**STAFF COMMENTS**

**HARTSVILLE/TROUSDALE CO. PLANNING COMMISSION**

**MARCH 7, 2022**

**1) Preliminary Subdivision Plat approval for The Towns at Melrose, a 1-lot Townhome Subdivision, on 11.15 acres (Map 26A Group A Parcel 5.00) in the 4th Civil District.**

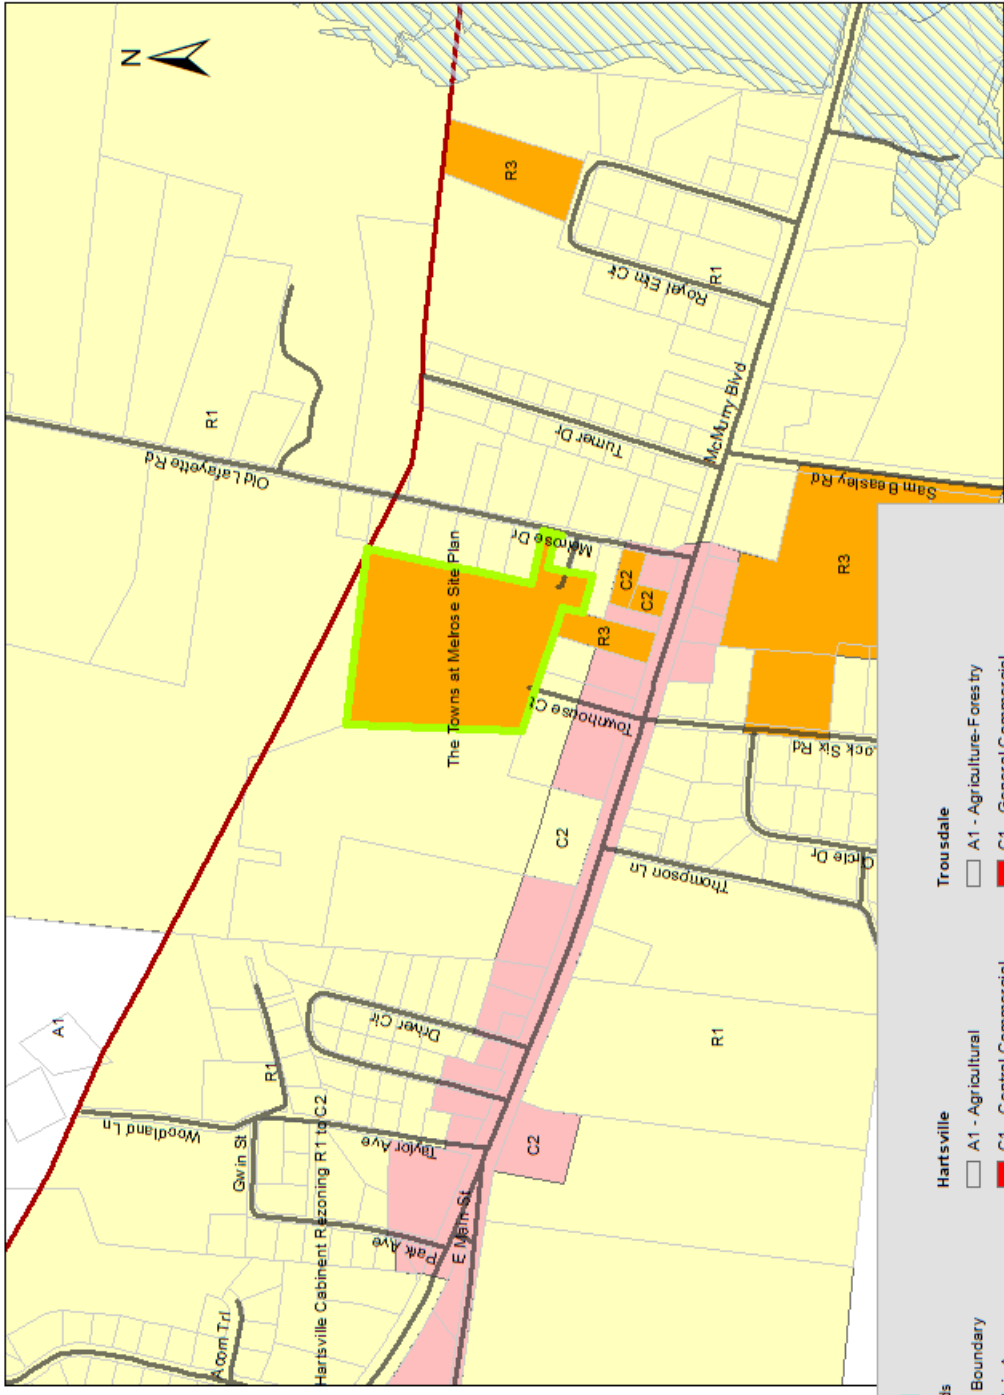
- a. **Sidewalks along Existing Streets (4-108.2)**- Sidewalks shall be required along an existing public street when sidewalks presently exist upon property that directly adjoins the proposed subdivision or are included within a plan for pedestrian ways.
  - i. The preliminary plat shows proposes sidewalks along both sides of the private streets throughout the development. The sidewalks end at the end of the access to Melrose Drive.
  - ii. Staff would ask that the applicant stub the sidewalks to the north and south property lines on either side of this access point, so the sidewalk network could be easily connected if sidewalks were ever constructed on Melrose.

- a) Please provide contour lines in accordance with Subdivision Regulations, 5-102.2, 19.
- b) Submittal and approval of construction plans, in compliance with 5-103 of the Subdivision Regulations, must be completed prior to review and consideration of the final plat.
  - a. For condominium subdivisions, shall contain "as built" drawings of all underground utilities, regardless of proposed ownership, and the construction design of all public facilities which are proposed for dedication to the governing body.

Staff recommends approval of the preliminary plat with the conditions that the sidewalk be extended to the north and south property lines at the point where it accesses Melrose Drive and contour lines are added in accordance with the subdivision regulations, and the planning commission classifies the subdivision as a horizontal property regime per the subdivision regulations.
